Proposed Renovations
Devon House 59 Duckworth Street
St. John's NL

Request to Amend City of St. John's Heritage Standards

To Allow the Extension Upward of the Rear Bay Window on the Designated Heritage Building

PROPOSED WINDOW ALTERATIONS

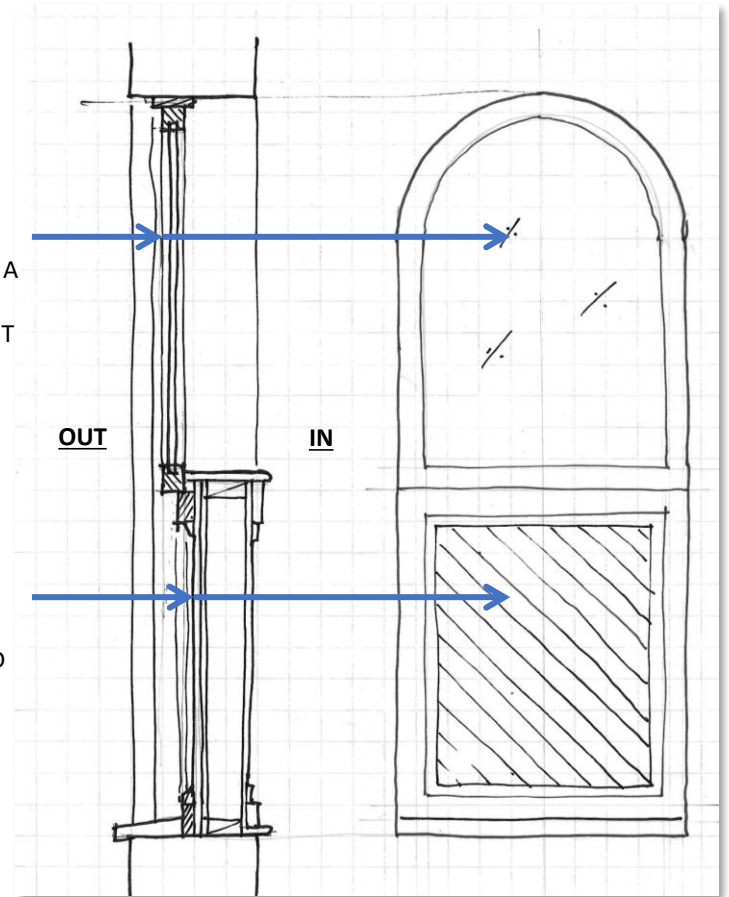
APPROVED TO MODIFY THE TOP WINDOW UNIT AND REPLACE EXISTING GLAZING WITH A WIRED GLASS AND REGULAR GLASS IN HERMETICALLY SEALED DOUBLE-GLAZED UNIT AND REINSTALL IN EXISTING FRAME AND OPENING TO MEET NBCC REQUIREMENTS.

APPROVED TO MODIFY BOTTOM WINDOW FRAME AND REPLACE GLASS WITH BLACK BACKPAINTED WIRED GLASS WITH FIRE RATED INSULATED WALL SYSTEM ON INTERIOR.

APPROVED THIS ALSO APPLIES TO PROPOSED INFILL OF LEVEL 1 AND LEVEL 3 WINDOWS ON WEST FAÇADE.

EXISTING LEVEL 3 DORMER BEFORE RENO

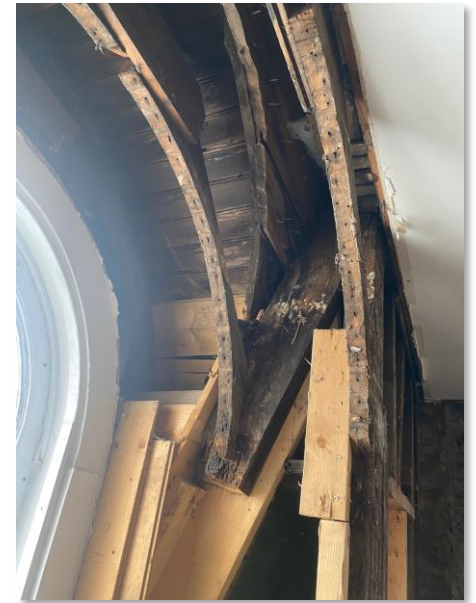
EXISTING ROT AND BANDAID MODIFICATIONS IN THE 80'S/90'S

DIMENSIONS OF THE ROUNDED TOP WINDOW AND DORMER AND STEP UP CANNOT FIT A REGULAR HEIGHT EXTERIOR DOOR.

' THE WHOLE OF THE MANSARD ROOF AND DORMER SYSTEMS NEEDS REPLACEMENT, HERE, ACROSS BACK AND ON THE EASTERN SIDE '

STEEL BEAM ADDED IN THE 80'S/90'S PRECLUDES EXTERIOR DECK AT FLOOR LEVEL AND A COUPLE OF STEPS UP.

HEIGHT OF PROPOSED KITCHEN CABINETS COUNTER THAT WILL BLOCK THE BOTTOM HALF OF THE WINDOW.

PROPOSED BAY WINDOW EXTENSION

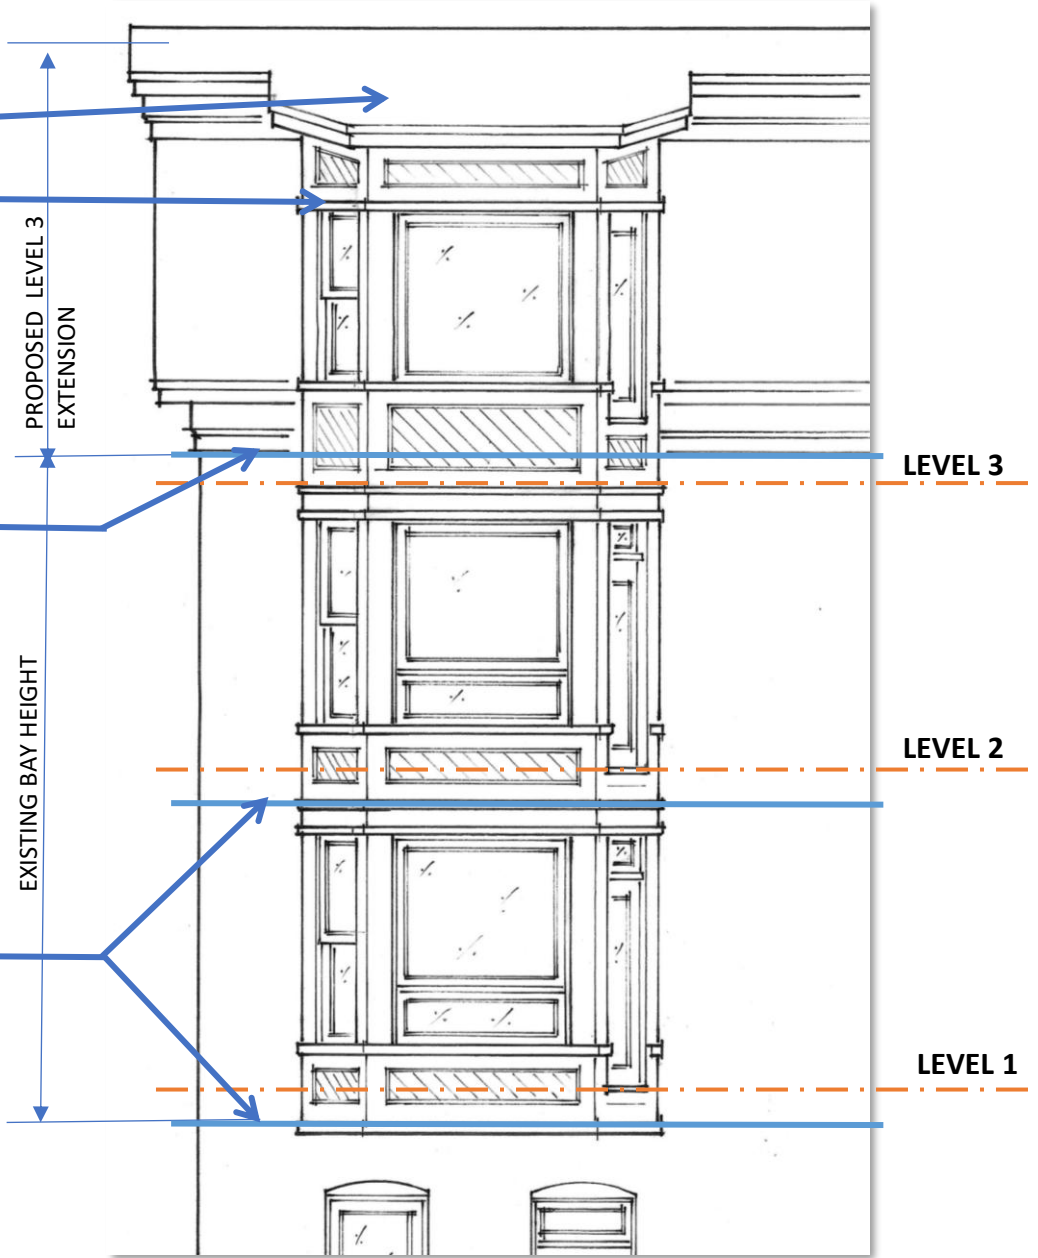
RECONSTRUCT THE EXISTING BAY WINDOW TO HERITAGE DETAILING AND **REQUEST** TO REMOVE DORMER WINDOW AND EXTEND THE BAY UP TO LEVEL 3 TO ALLOW PROPER ACCESS TO THE EXTERIOR DECK

LEVEL 3 EXTERIOR DECK LEVEL ABOVE FLOOR DUE TO RAISED BEAM BUT 6"-8" BELOW DOOR SILL

LEVELS 1 AND 2 DECKS 6"-8" BELOW DOOR SILL
